A Submission by RAPS

Residents Against Polluting Stacks (Inc.)

**Inquiry into the Single Exhaust Stack at Turrella
for the M5 East Motorway**

**General Purpose Standing Committee No.5
of the Legislative Council
of the State of New South Wales**

400m radius superimposed on aerial photo of the area.

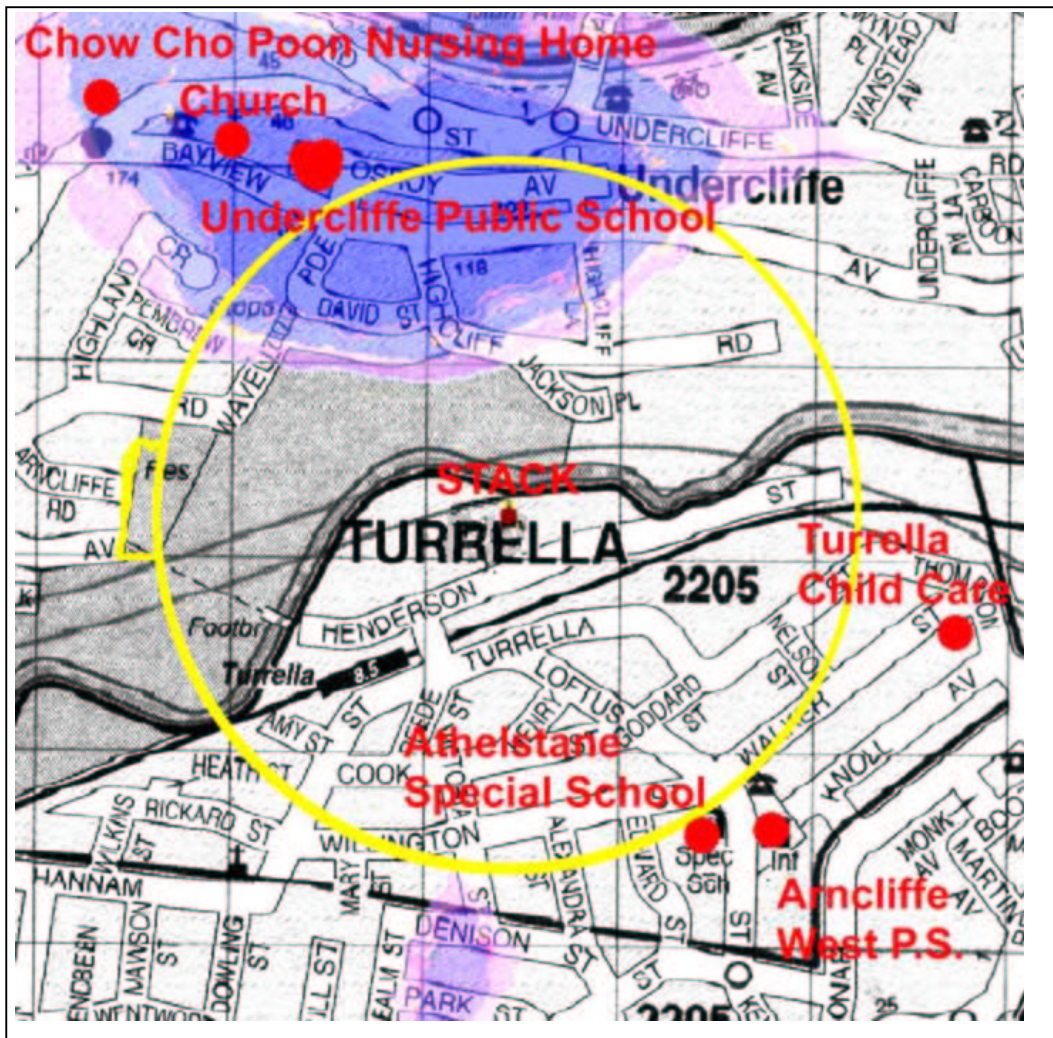
As the following two illustrations demonstrate, **there is no discernible logic behind the arbitrary 400m radius. It correlates neither with the visual catchment of the stack, nor the areas worst affected by pollution. In fact many of the worst affected homes, schools, child and aged care facilities are excluded. Furthermore, about 70% of the area comprises parkland, railway property and private businesses which are ineligible.**
